**Re: In the Matter of the Application of The York Water Company, Under Sections 507, 1102(a)(1) and 1102(a)(3) of the Public Utility Code, for approval of the right of The York Water Company to (1) enter into a municipal contract to acquire certain public wastewater facilities from Letterkenny Township Municipal Authority; and (2) begin to offer or furnish wastewater service to the public in a portion of Letterkenny Township, Franklin County, Pennsylvania
Docket No. A-2020-3019424**

Bureau of Technical Utility Services Water/Wastewater Division
Data Request Set 1

Application of The York Water Company - Wastewater to Acquire the Letterkenny Township
Municipal Authority Wastewater System at Docket No. A-2020-3019424

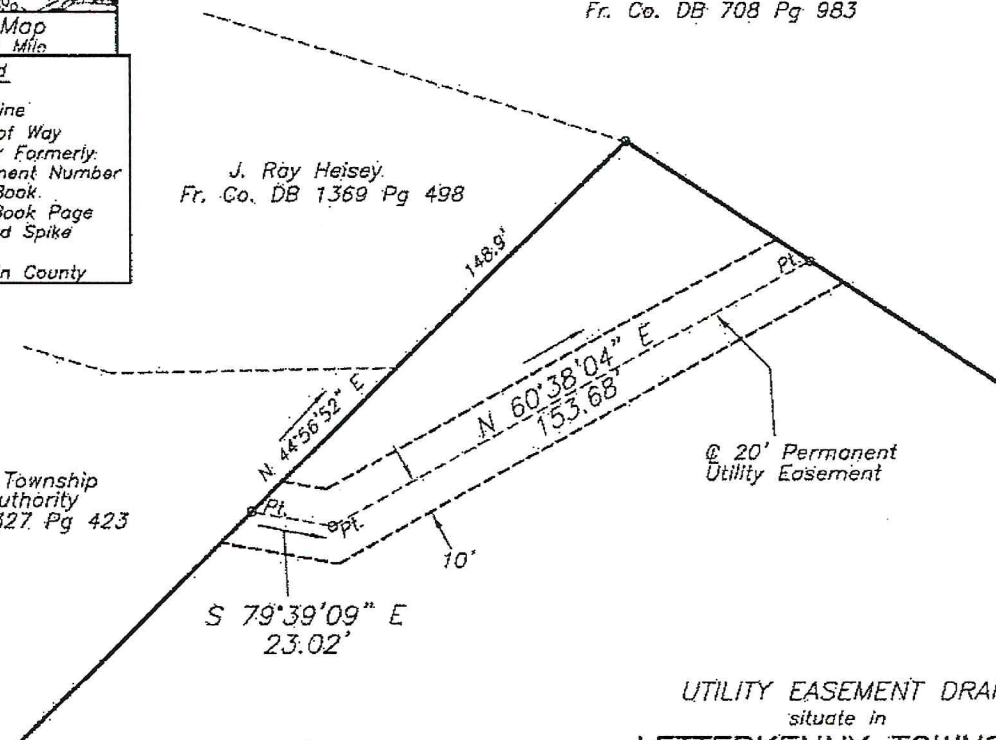
The Application's Exhibit Q-4 provides a map entitled "LTMA Wastewater Treatment Plant Outfall" dated December 16, 2019. The map depicts a 20-foot permanent utility easement for a proposed 8-inch diameter sanitary sewer outfall pipe and outlet to Conodogouinet Creek. Please provide evidence of a recorded easement for these future improvements.

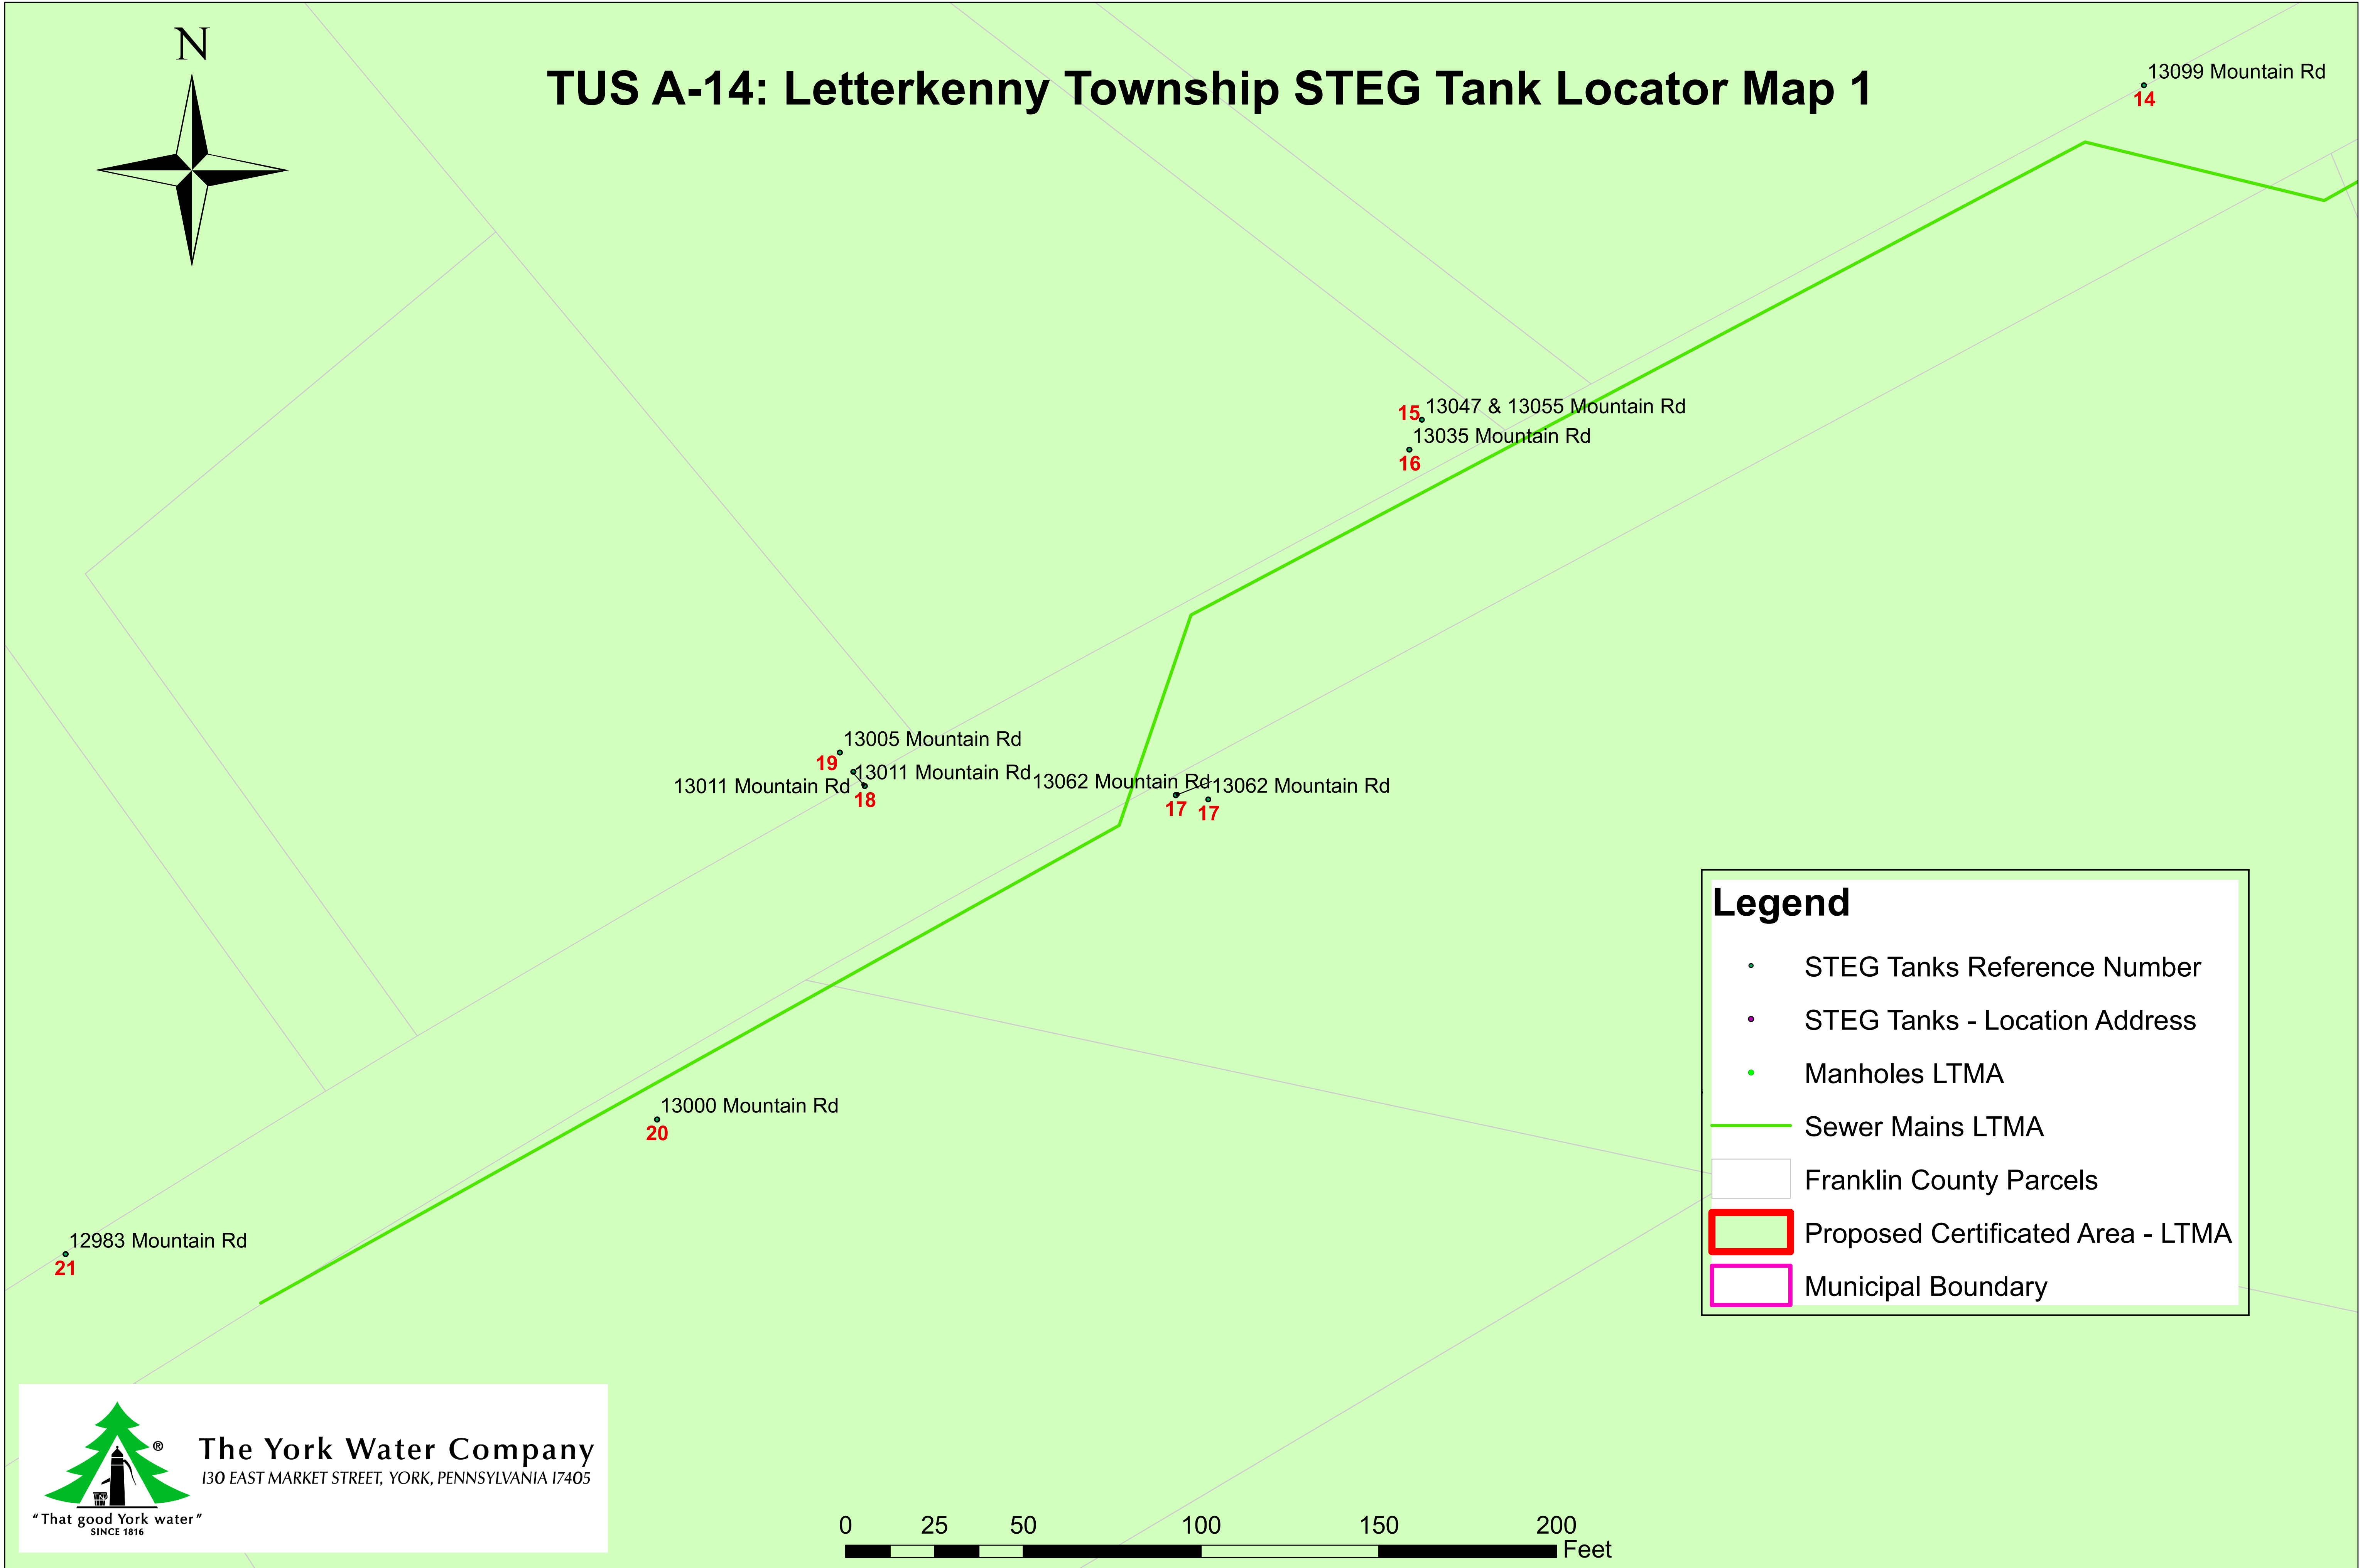
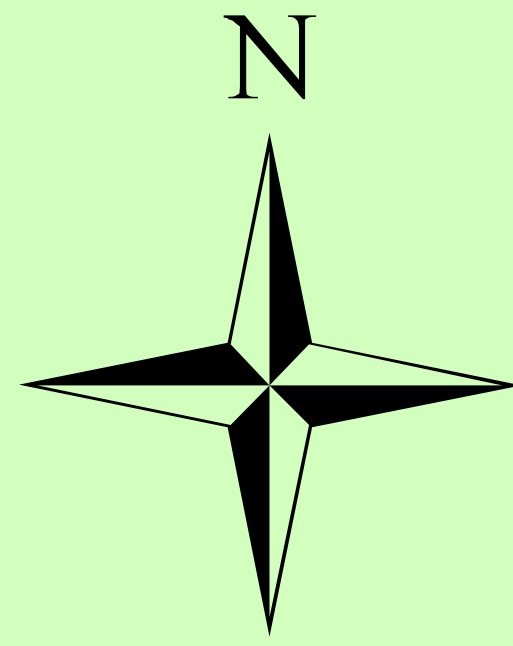
Page 3 of Part 3 of the 2019 Special Study, provided in the Application's Exhibit T-2, indicates the STEG system is comprised of approximately 25 effluent pumps and septic tanks. However, the Application's Paragraph 8 indicates 24 septic tanks without effluent pumps in its list of wastewater system components. Additionally, the map provided as the Application's Exhibit D appears to depict only 23 STEG system tanks. Please explain these apparent discrepancies and clarify the total number of components (i.e., tanks and effluent pumps) comprising the STEG system.

Due to the close proximity of several of the tanks, the scale of Application's Exhibit D did not allow for a clear depiction of each of the tanks. Attachment A-14 that is attached to this answer provides a more detailed scale. The tanks are labeled by a property address and a reference number as found in Attachment A-2(a).

Letterkenny Township Parcels Listed in TUS A-15

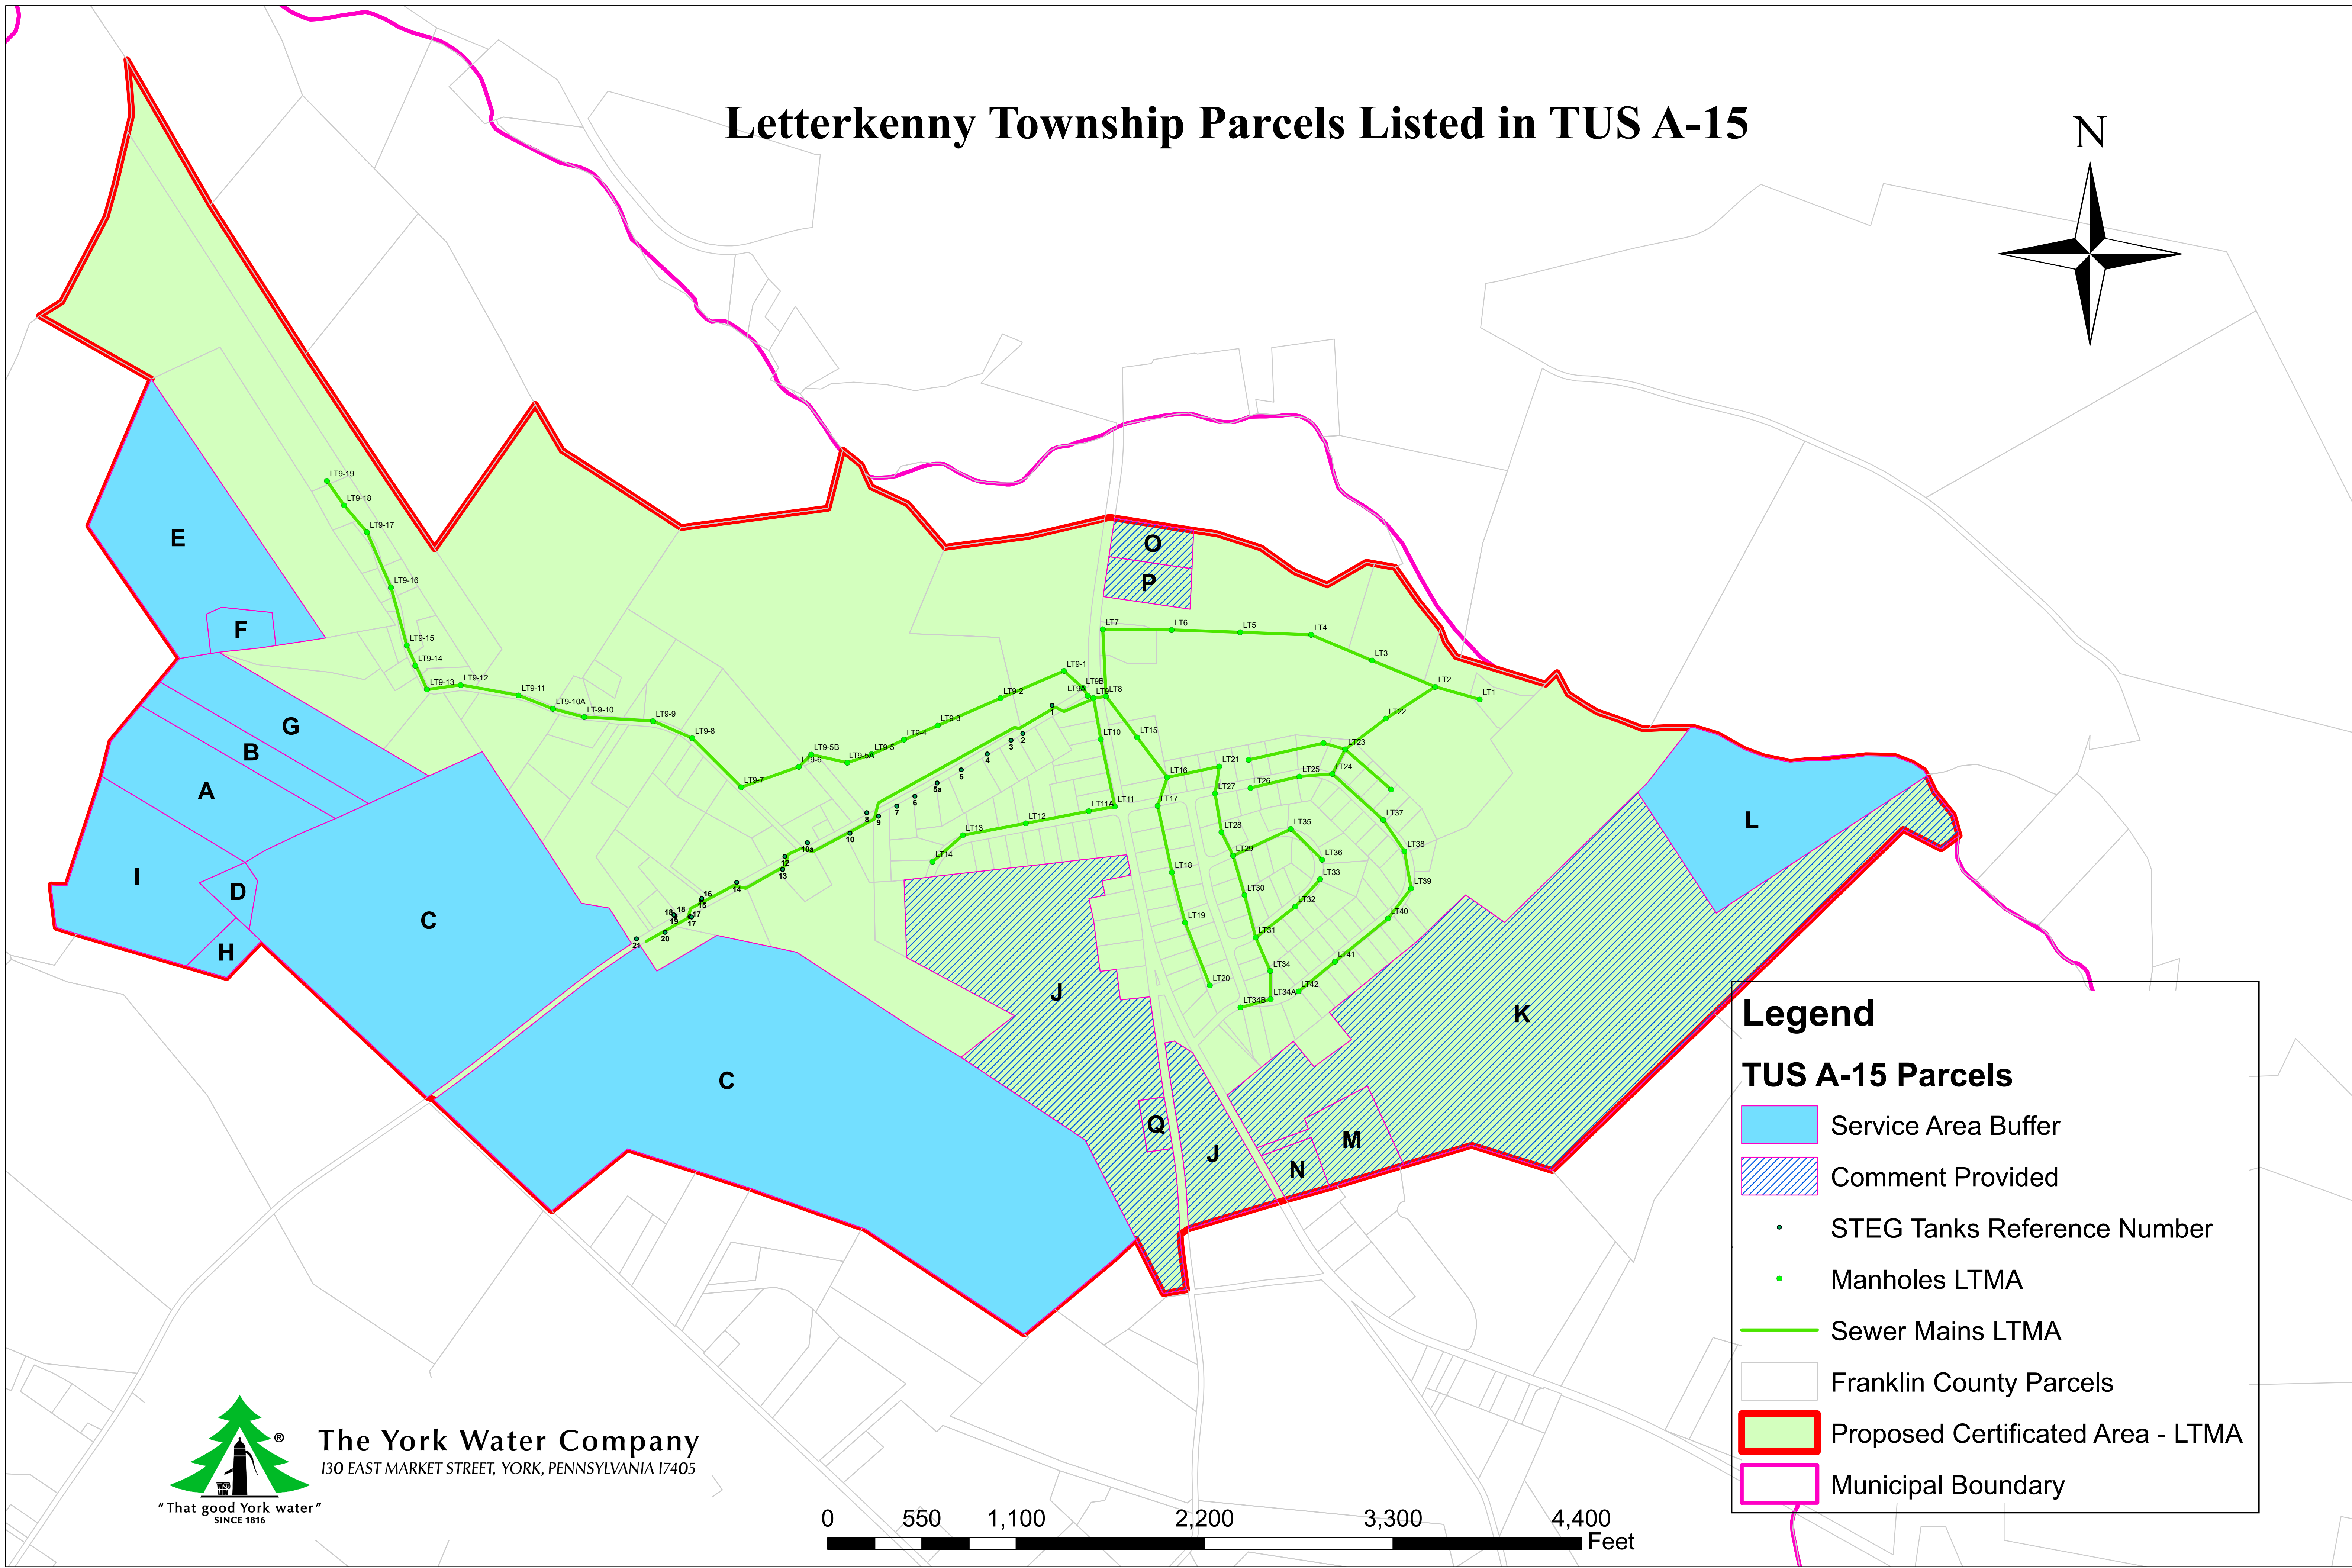
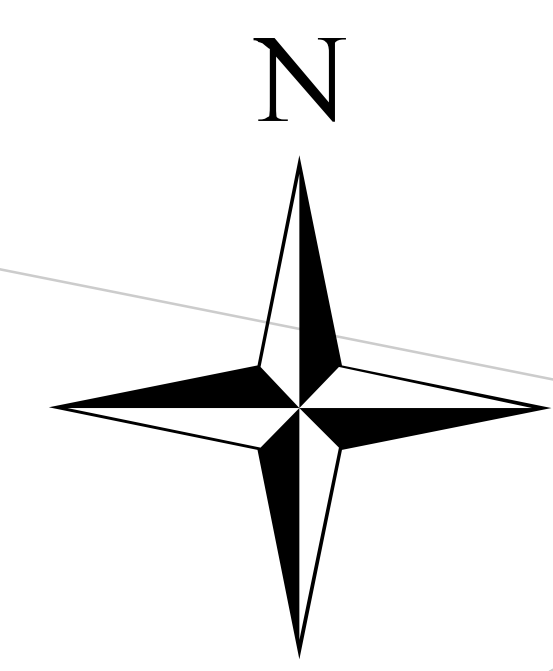
Figure 1 of the Application's Exhibit T-2 does not clearly define boundaries of LTMA's existing wastewater service area. Additionally, Page 2 of Part 3 of the 2019 Special Study states that the areas identified in the 2003 Act 537 as needing sewage collection and treatment have been addressed. Please justify the inclusion of the following Franklin County Unified Parcel Identification numbers in York-WW's requested service territory by providing: evidence the property is included in LTMA's existing service area; evidence the property is not currently receiving adequate wastewater service by other means; specific references in LTMA's approved Act 537 plan that indicates Letterkenny Township intends to provide public wastewater service to the property; and copies of any requests for public wastewater service:

As described in Attachment A-15, Parcel M is currently served by the LTMA sanitary sewer system via a private service lateral crossing Parcel K. Parcel J submitted an approved sewer module in 1999 for 44 residential and 1 commercial connections. Parcel Q was included in the event Parcel J was served. Figure 1 of Exhibit T-2 attached to York Water's Application is a map showing the general area currently served by LTMA. York Water proposes a wastewater service territory that allows the orderly growth of the Company's wastewater territory and affords the residents of Letterkenny Township adjacent to properties currently served with the opportunity to connect to public wastewater in accordance with the provisions of the Company's wastewater tariff.
